Responses to comments by referee #1 (Konstantinos X. Soulis)

**Reviewer #1:**

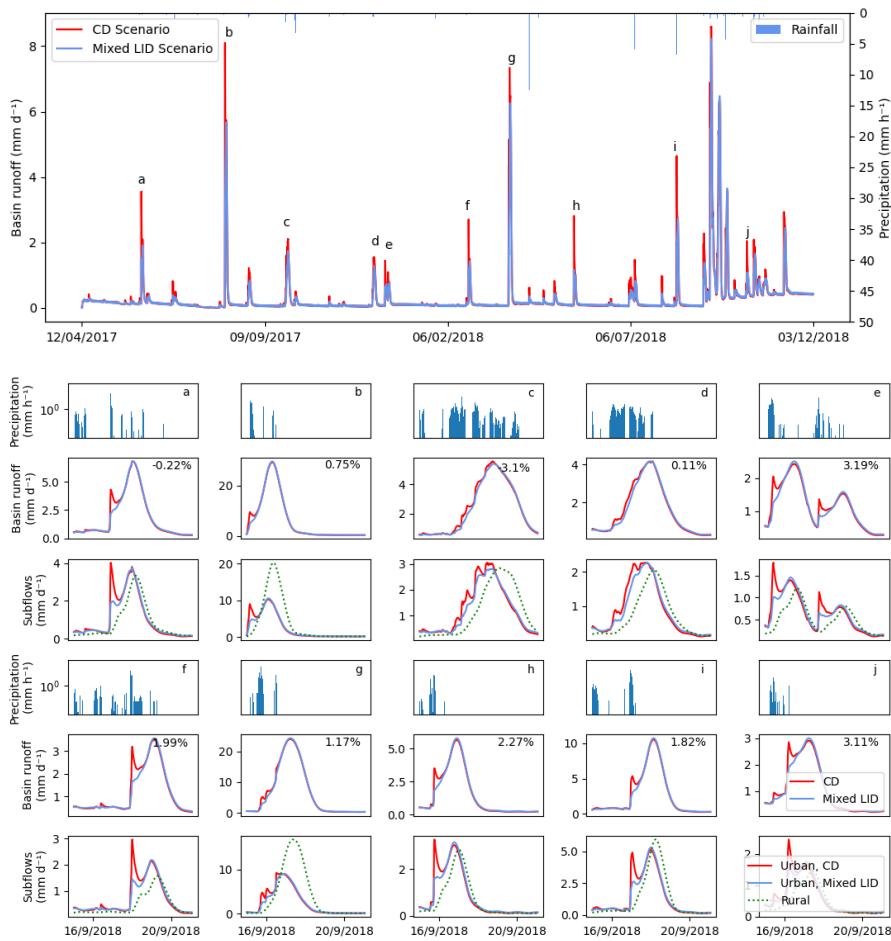
24) *The reduction of peak reduction ability of LID in wet periods and for big storms is logical and was also discussed in previous studies. However, The coincidence of rural and LID peaks that leads to a small increase of the combined peak can be the result of a coincidence. Considering also the uncertainty of the model performance as regards LID hydrological response, I believe that more caution is required before drawing these conclusions. (page 18, line 463)*

25) *Please see my previous comment. I believe that the obtained results cannot justify this as a general conclusion for combined urban and rural watersheds, considering also the modeling uncertainties. This could be the case in very specific cases, but not generally. (page 23, line 496)*

Response to 24 and 25: We appreciate this suggestion. Although completely avoid of model uncertainty is impossible, more tests about the rainfall-runoff relationship are helpful. To further

confirm LID influences in flood season, ten precipitation events with different rain intensities and durations were selected from the 600-day precipitation observation. These selected rain events were tested after 15th Sep. 2018 (flood season with the saturated subsurface soils in rural areas) in mixed LID scenario. Ten original peak runoffs corresponding to the selected rain events and ten test results were shown below.

Among ten test precipitation events, eight basin peak values were increased from 0.1 % to 3.2 % after the implementation of mixed LID practices, while only two peaks (a and c) were decreased by -0.2 % and 3.1 %. Especially for three extreme large rainstorms, the peak values increased by 0.75 % (b), 1.17% (g), and 1.82% (i). Even though the increase is small, it is to be concluded that during extremely wet conditions, the effect of implementing LID measures on peak flow reduction is negligible, if not negative in basins with combined urban and rural land use.

Based on this test, a paragraph was added in Section 4.4 LID performance in flood season. Considering the limitation of space, these two figures were not shown in the manuscript.
